Response to Comments
Draft Air Pollution Control Permit to Construct for North Springfield Sustainable Energy Project, LLC (NSSEP) issued August 9, 2012

On August 9, 2012 the Vermont Agency of Natural Resources, Department of Environmental Conservation, Air Pollution Control Division (Agency) issued a Draft Air Pollution Control Permit to Construct to North Springfield Sustainable Energy Project, LLC (NSSEP). The Agency then held a public meeting on August 29, 2012 to accept oral and written comments regarding the draft air permit. In addition, the Agency accepted written comments on the Draft Air Pollution Control Permit to Construct until September 10, 2012.

Figure 2: Significant Impact Area: 1-hr NO₂:

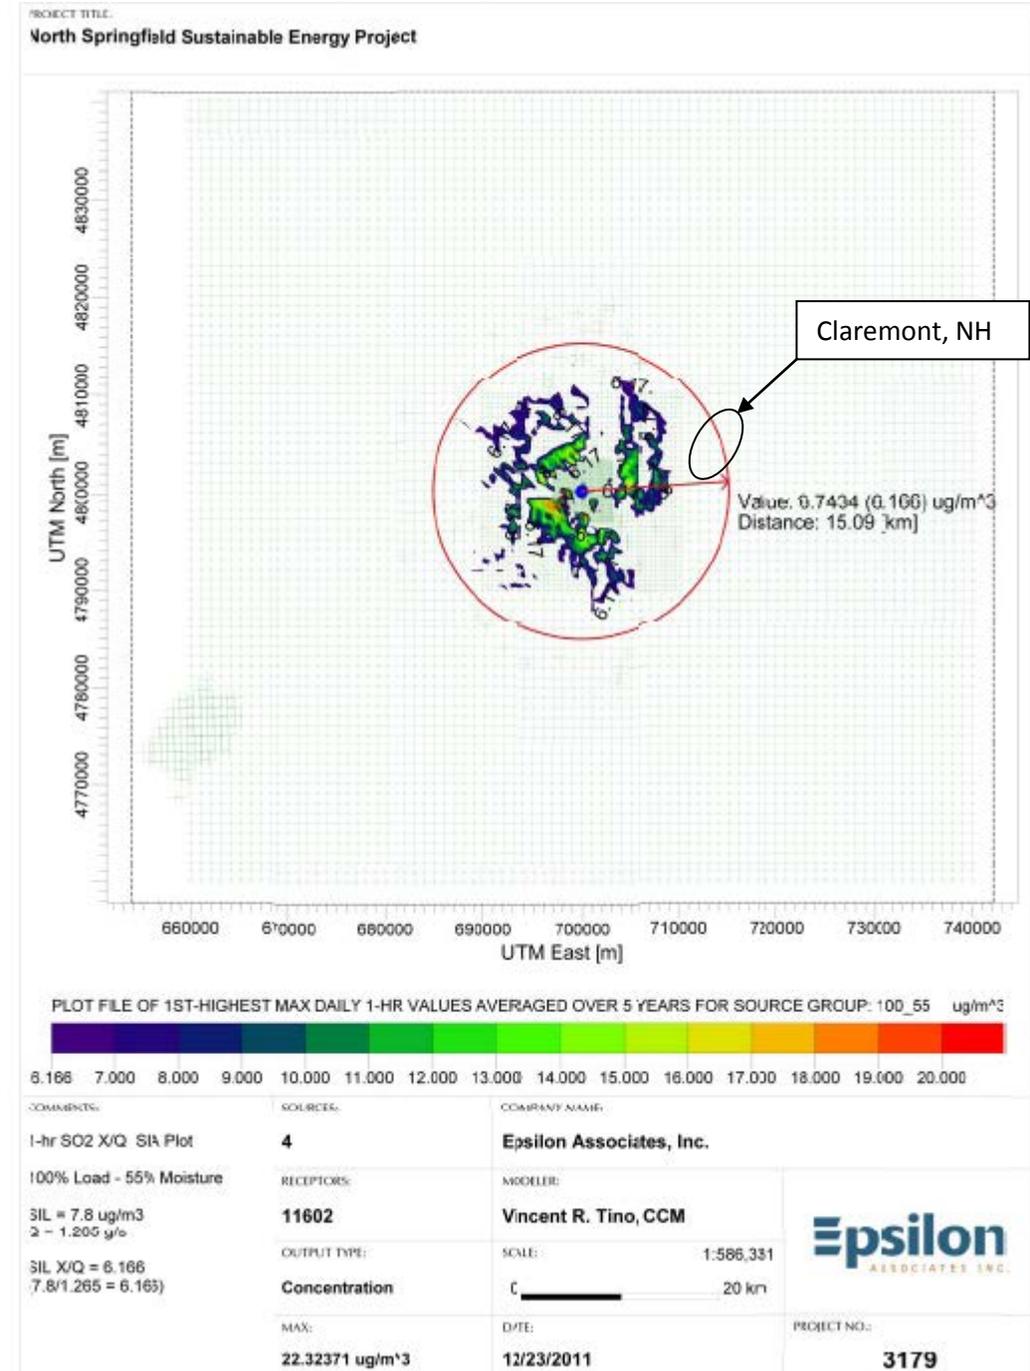
Comment #10: SIL and SIA modeling results are obfuscated and appear to have been misrepresented (Commenter #26)

So which is it? We are told on page 7 that several pollutant measures have "predicted concentrations that were greater than their respective SIL", then on page 8 we are told that the predicted impacts are "well below" the significant impact level. Then we are told in the table on page 9 that for the pollutants requiring cumulative source modeling, even though the NAAQS are already

For NO₂, the radius of the SIA was also great enough that it also included the two air pollution sources in Claremont, NH. The interactive modeling identified potential exceedances of the 1-hr NO₂ at 12 receptors near Claremont. The modeling analysis reviewed the 4 operating scenarios and found the highest predicted impact from the NSSEP occurred with the “75% boiler load/45% wood moisture content” scenario. The attached map (Figure 2) shows the locations of 12 receptors where there are predicted exceedances of the 1-hr NO₂ NAAQS. The contribution from for the NSSEP 75%/45% scenario is also marked on the map: the highest contribution from the NSSEP is 4.06 µg/m³ which is below the SIL of 7.5 µg/m³.

Figure 1: Significant Impact Area – 1-hr SO₂

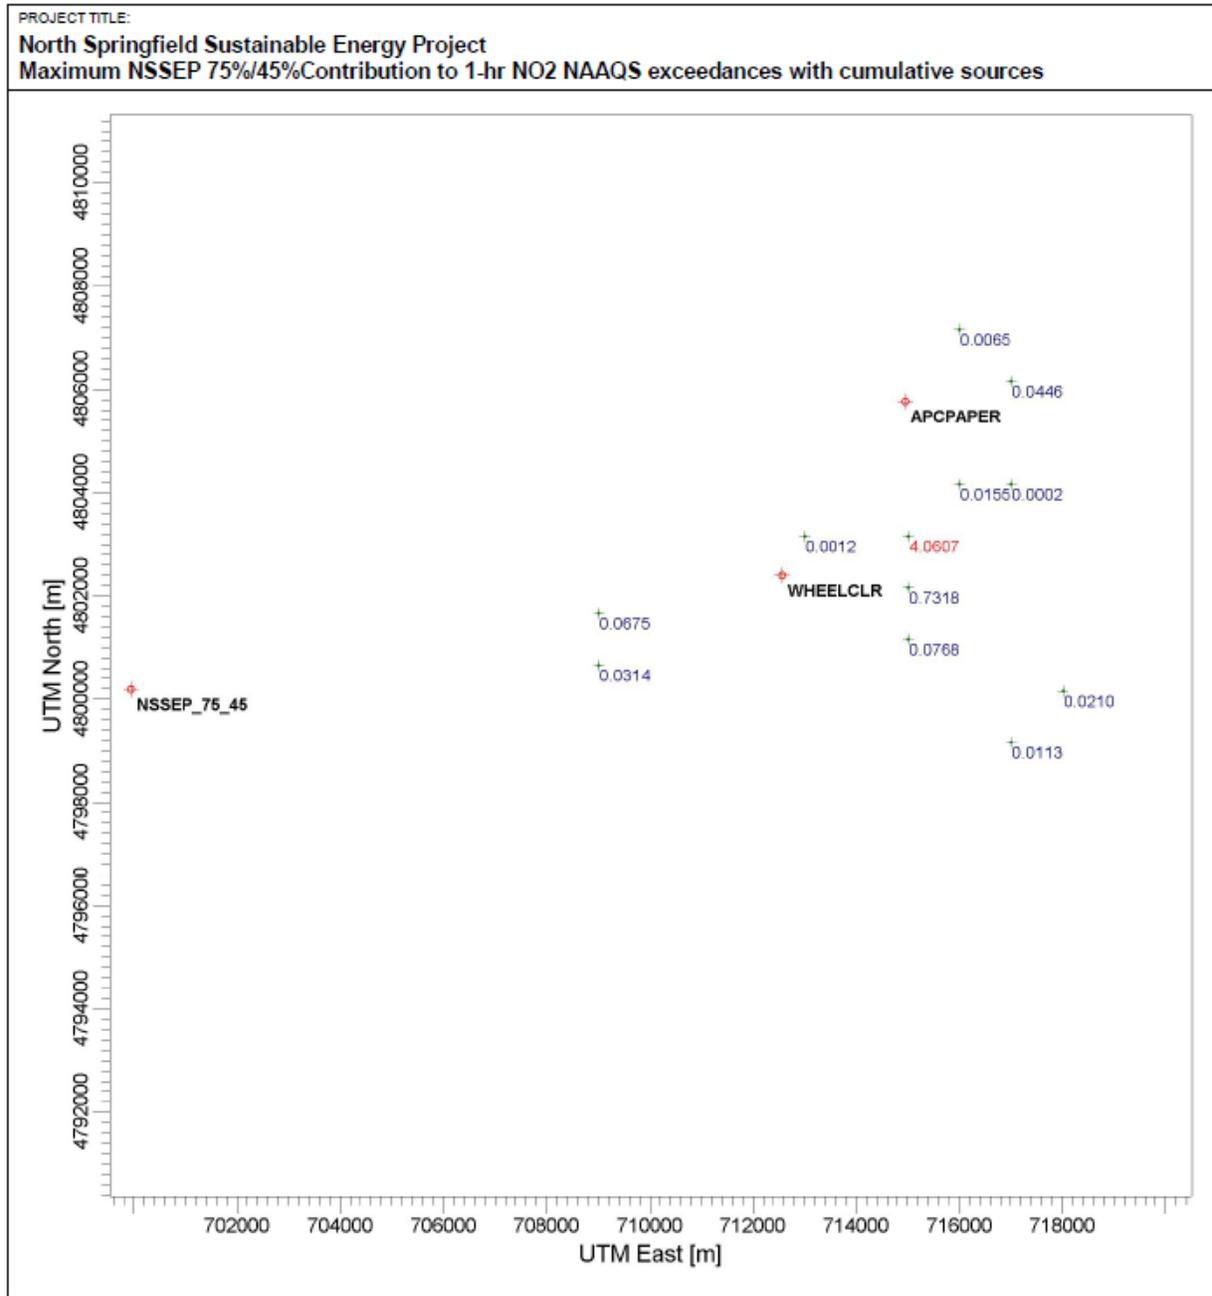
But then on page 8, we are told: *For the 1-hr NO₂ and SO₂ standards it was necessary to identify the Facility's contribution to impacts at the receptors that had a total impact that is greater than the NAAQS. This analysis was done and it was determined that the predicted impacts from this proposed project at those receptors were well below the significant impact level. This review concluded that the Facility does not contribute to these predicted violations of the NAAQS.*

exceeded for the 1-hour NO₂ and SO₂ standards, not to worry, the contribution of NSSEP is so small, it does “not contribute” to the violations.

The public should not have to work this hard to interpret an air permit. This text is impenetrable, and the presentation of information conveys the impression that there is a problem with this facility’s emissions, but they are hiding it. Worse yet, ANR signing off on a permit containing such confusing verbiage makes it look like ANR isn’t minding the store. This permit needs work, and if ANR has the slightest doubt about the modeling results from the facility, they should require the modeling to be repeated, with the Agency supervising closely.

Response: To determine the size of the significant impact area (SIA), just the emissions from the proposed source are modeled to identify the maximum distance from the source where modeled impacts equal or exceed the significant impact limit (SIL). The nature of modeling is that the impacts will be distributed unevenly due to the variability in the meteorological data such as mixing height, stability and wind speed as well as the topography of the land. The furthest away receptor with a predicted impact at or above the SIL will establish the radius of the SIA, and the SIA, a circle in shape, will cover large areas where the predicted impacts were below the SIL. This is a conservative approach for identifying other nearby sources that may have an overlapping impact area with NSSEP. To use the actual individual points of significant impact to identify such sources would be more difficult and prone to missing potentially applicable nearby sources.

The shaded areas on the attached map (Figure 1) show where there are modeled impacts from NSSEP for SO₂ at or above the SIL. This map also has a circle representing the SIA. There are many receptors within the SIA that are below the SIL (represented by the white area), including the area around Claremont, NH. Since the radius of the SIA was great enough that it included the two air pollution sources in Claremont, these two existing sources were included in the ‘interactive modeling.’ Interactive modeling is conducted to make sure that new projects do not combine with existing significant source of air pollution and result in exceedances of the NAAQS.

As noted in the draft permit and technical support document, the interactive modeling identified potential exceedances of the 1-hr SO₂ NAAQS at 263 receptors near Claremont. The highest modeled contribution from NSSEP at these receptors was 0.11 µg/m³ which is well below the SIL of 7.8 µg/m³. Based on this data, the Agency determined that the NSSEP does not cause or contribute to these predicted violations of the 1-hr SO₂ NAAQS.
